**Project: Hurricane Laura Stom Repairs - Rosteet Annex**

**Addendum No. 2**

**Addendum Number 2**  
December 7, 2023

**Calcasieu Parish School Board**  
Rosteet Annex  
Engineer's Project Number: 23023

**A-ME1**  
MECHANICAL & ELECTRICAL  
SITE PLAN

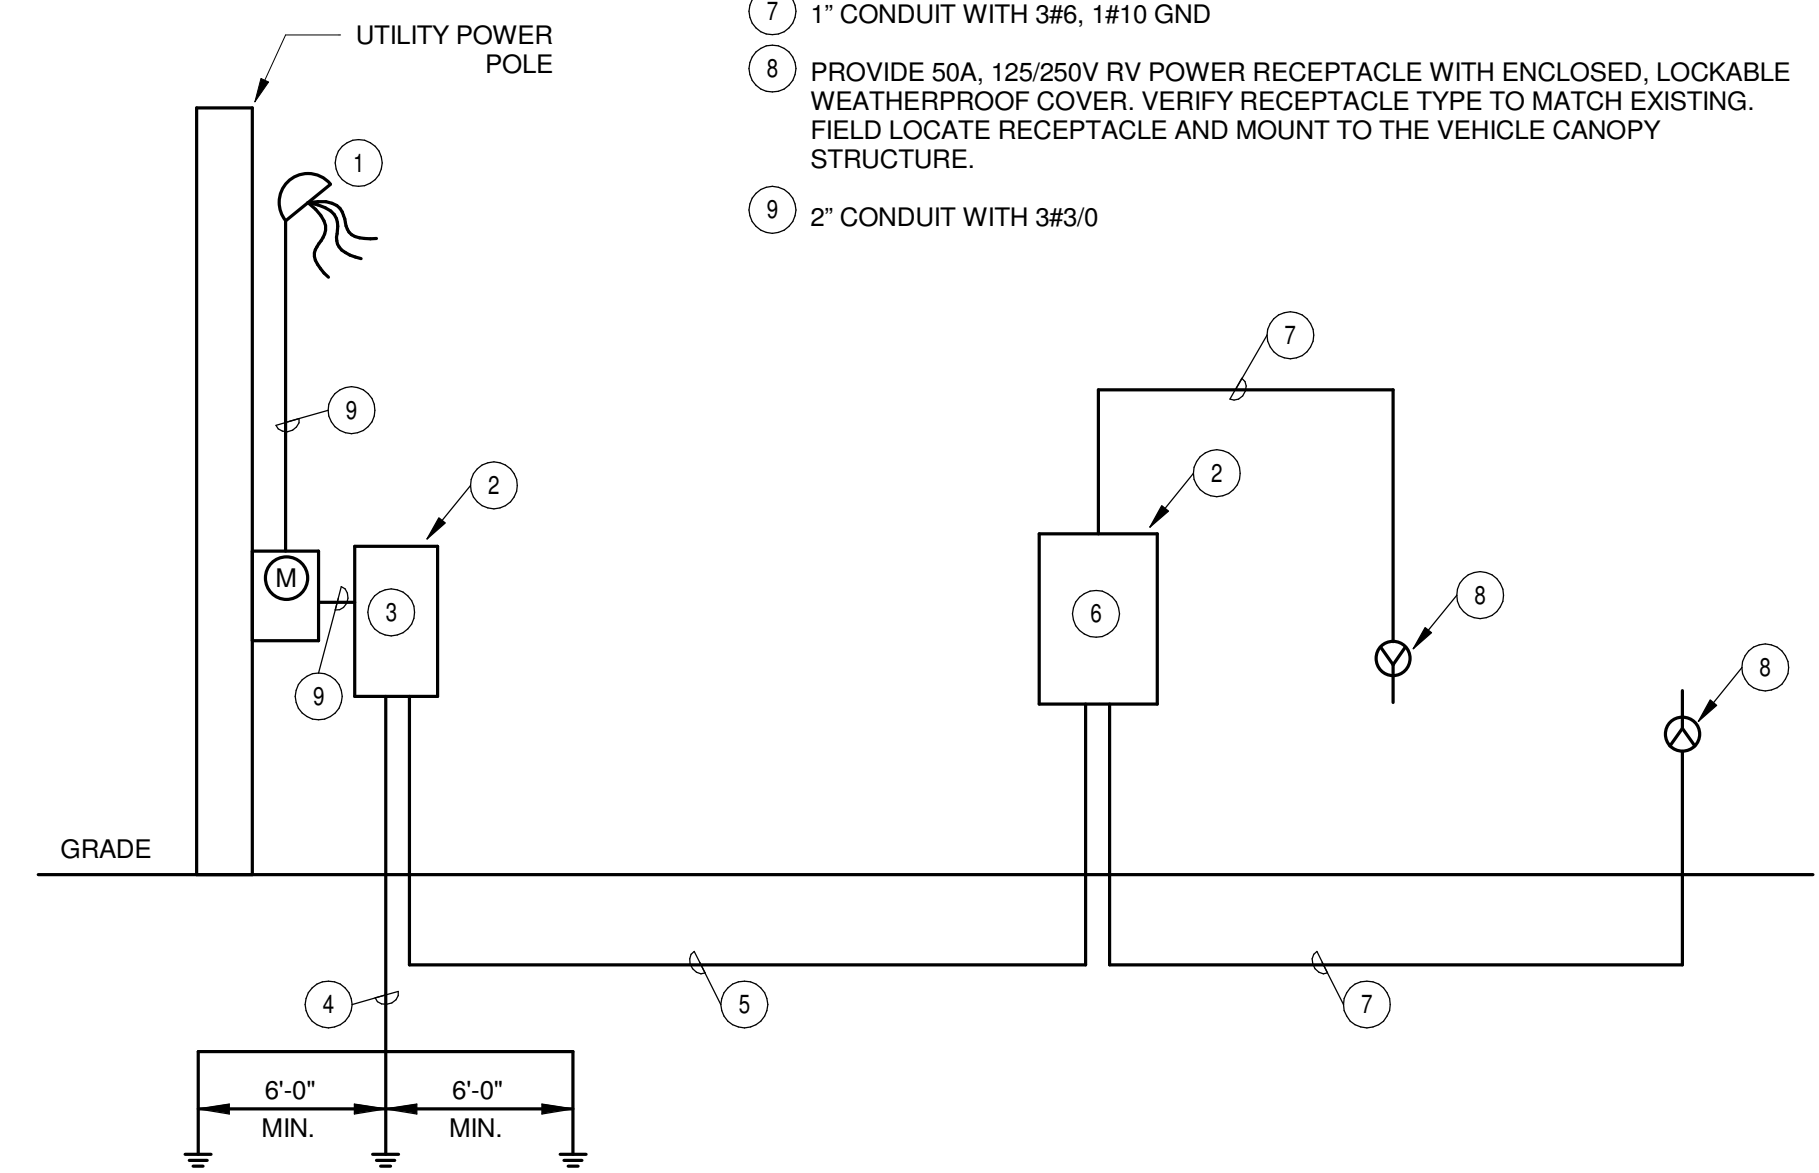
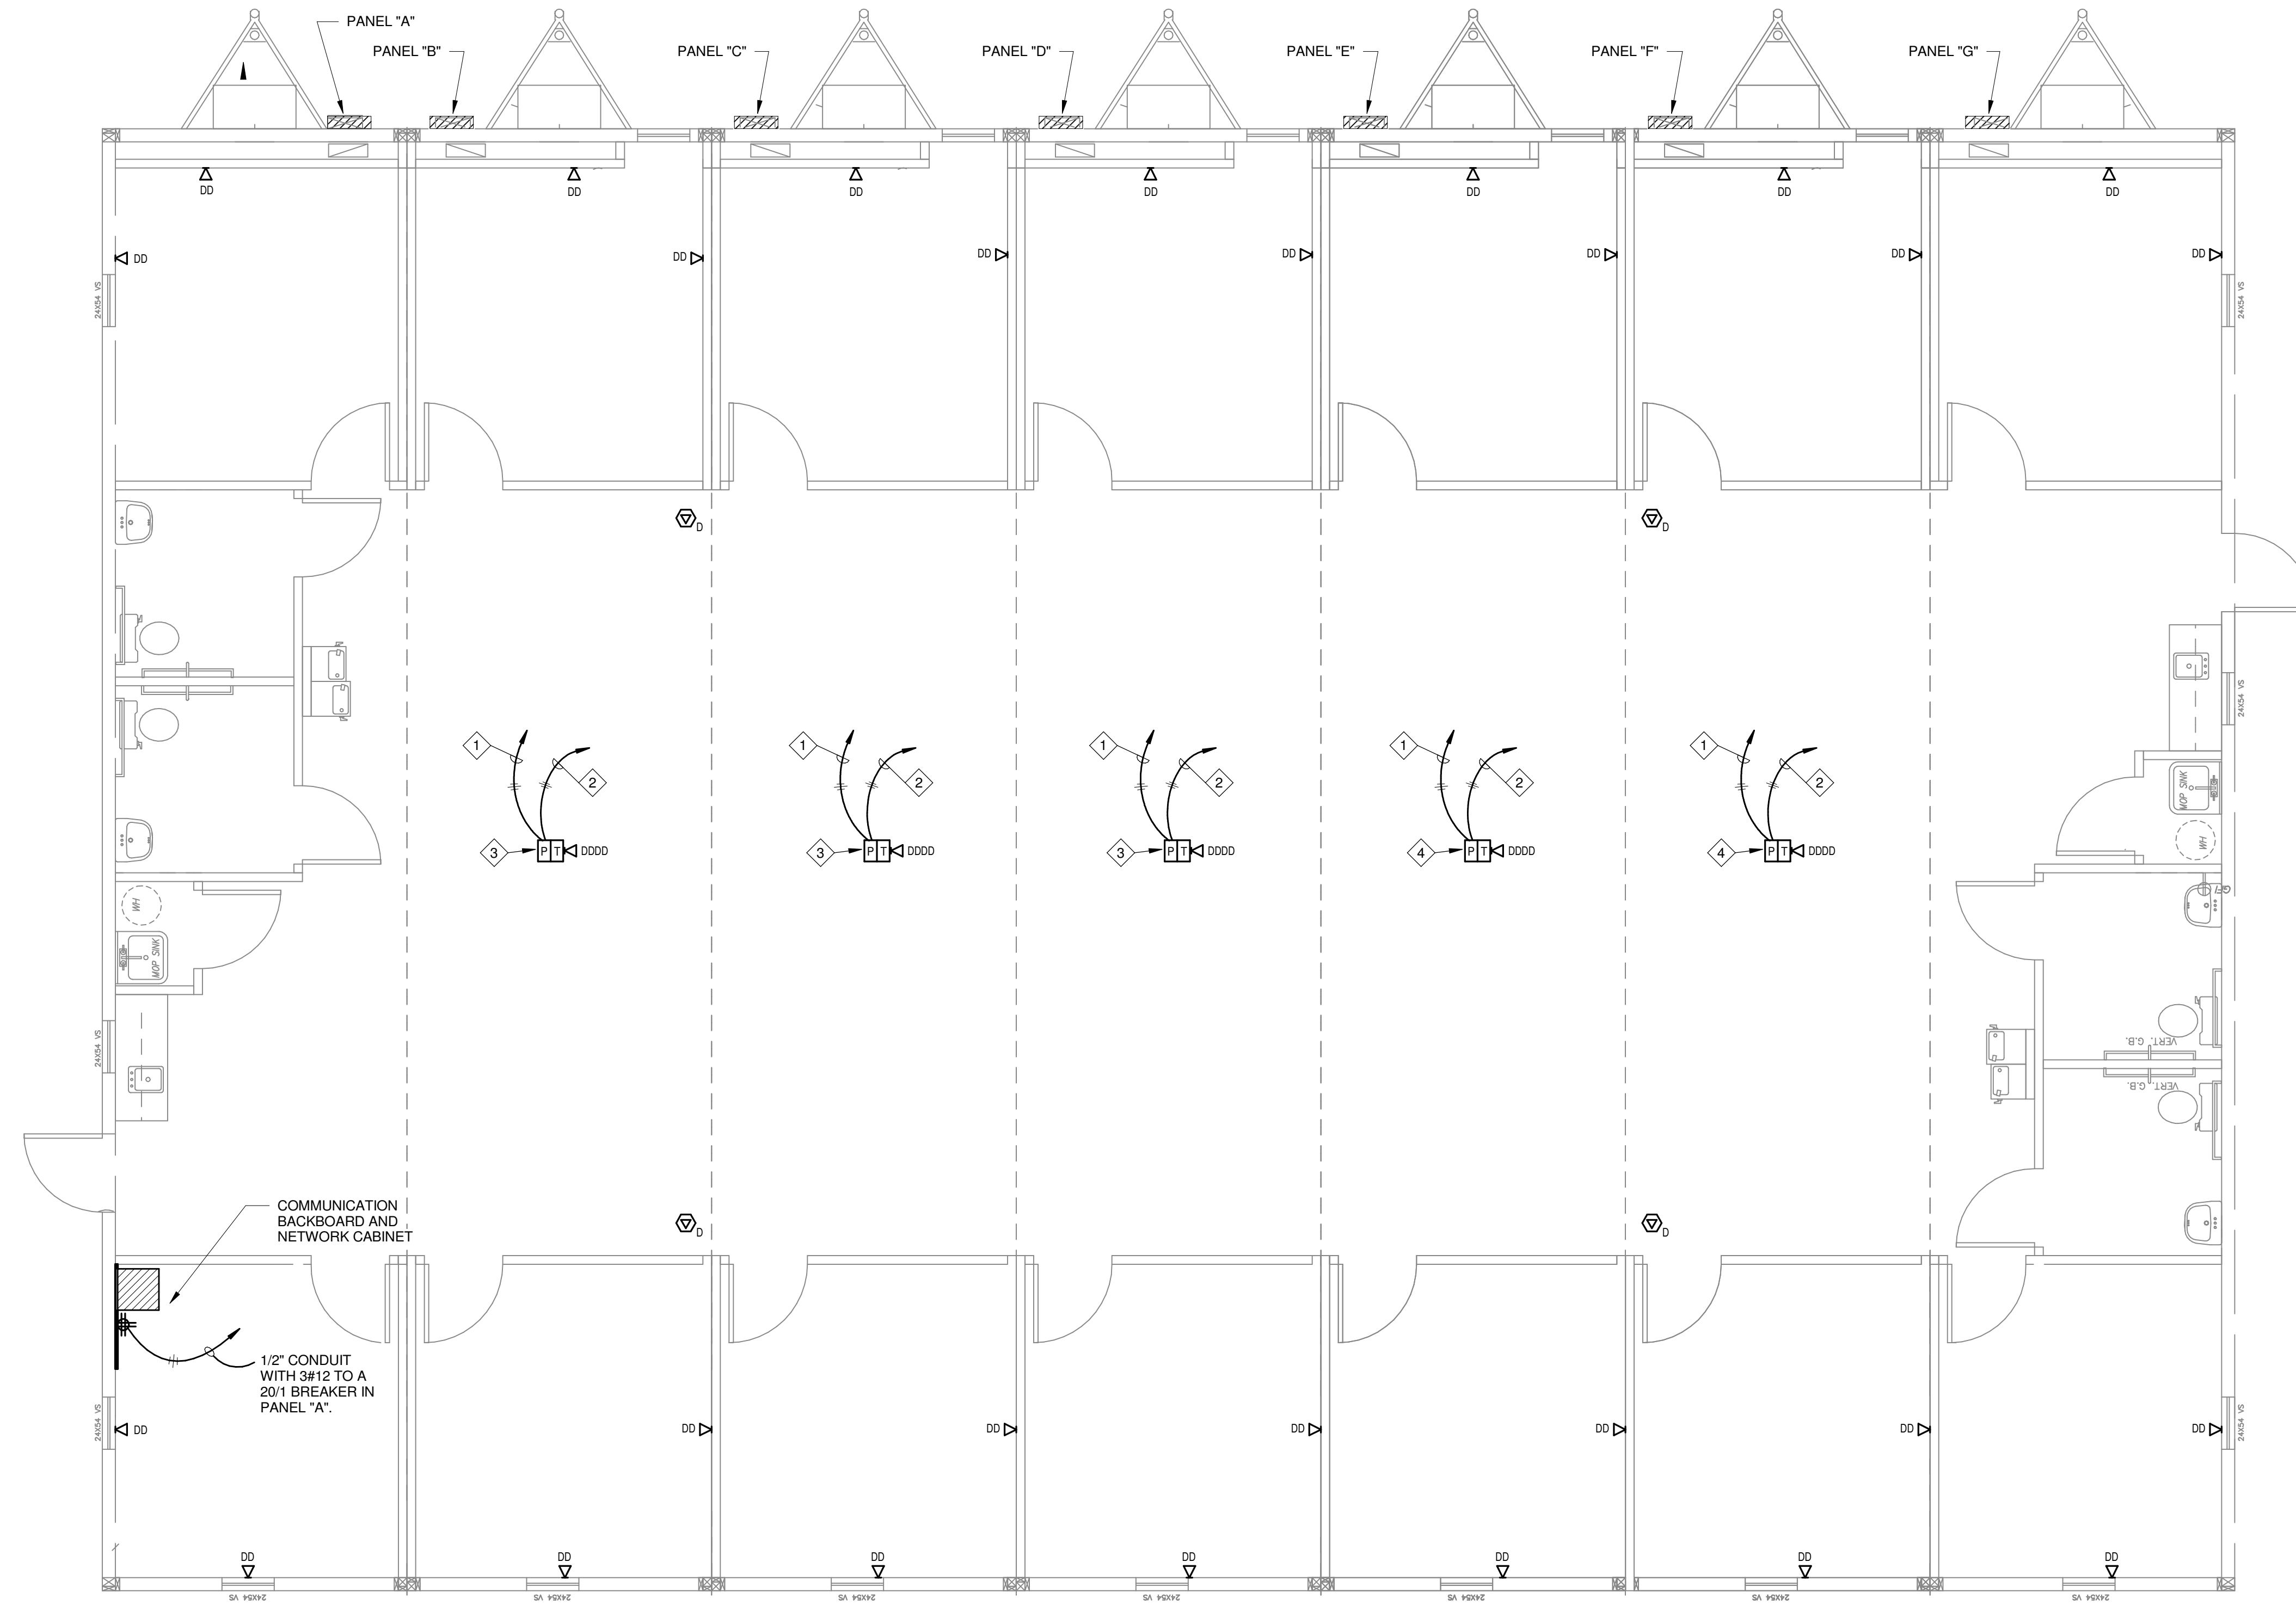
Item No. 5 - See attached revised sheets A-ME1, A-ME5, A-ME6.

- 1 REPLACE EXISTING DAMAGED SECONDARY UTILITY POWER POLE, METER AND OUTDOOR LOADCENTER IN THIS AREA. SEE RISER.
- 2 REMOVE AND REINSTALL EXISTING ELECTRICAL PANEL MOUNTED TO SIDING THAT IS DAMAGED. SEE RISER.

- 3 REPLACE BROKEN RV RECEPTACLE AND ASSOCIATED CIRCUIT. VERIFY EXISTING RECEPTACLE TYPE. SEE RISER.
- 4 REPLACE DAMAGED PIPE CHASE FOR SUMP PUMP CORD AND PLUG IN THIS AREA.

- 2 INSTALL LOADCENTER AND METER BASE ON UNISTRUT RACK AT POLE.
- 3 PROVIDE AND INSTALL A 200A, 20 CIRCUIT, 120/240V, 10KAIC LOADCENTER WITH NEMA 3R ENCLOSURE, 200A MCB, 1-100/2 CIRCUIT BREAKER, 1-70/2 CIRCUIT BREAKER, AND 2-20/1 CIRCUIT BREAKERS. FURNISH AND INSTALL 1-20A 120V, GFCI PROTECTED, WR TYPE CONVENIENCE OUTLET WITH WEATHERPROOF COVER AT PANEL WITH 3#12 IN 1/2" CONDUIT TO ONE OF THE 20/1 BREAKERS.

- 4 3/4" CONDUIT WITH #4 CU TO (3) 3/4" X 10' COPPER CLAD GROUND RODS
- 5 1 1/2" CONDUIT WITH 3#2, 1#8 GND TO A 100/2 CIRCUIT BREAKER
- 6 PROVIDE AND INSTALL A 100A, 12 CIRCUIT, 120/240V, 10KAIC LOADCENTER WITH NEMA 3R ENCLOSURE AND 2-50/2 CIRCUIT BREAKERS TO SERVE THE RV RECEPTACLES, AND 1-20/1 CIRCUIT BREAKER. FURNISH AND INSTALL 1-20A 120V, GFCI PROTECTED, WR TYPE CONVENIENCE OUTLET WITH WEATHERPROOF COVER AT PANEL WITH 3#12 IN 1/2" CONDUIT TO THE 20/1 BREAKERS.

- 7 1" CONDUIT WITH 3#6, 1#10 GND
- 8 PROVIDE 50A, 125/250V RV POWER RECEPTACLE WITH ENCLOSED, LOCKABLE WEATHERPROOF COVER. VERIFY RECEPTACLE TYPE TO MATCH EXISTING. FIELD LOCATE RECEPTACLE AND MOUNT TO THE VEHICLE CANOPY STRUCTURE.
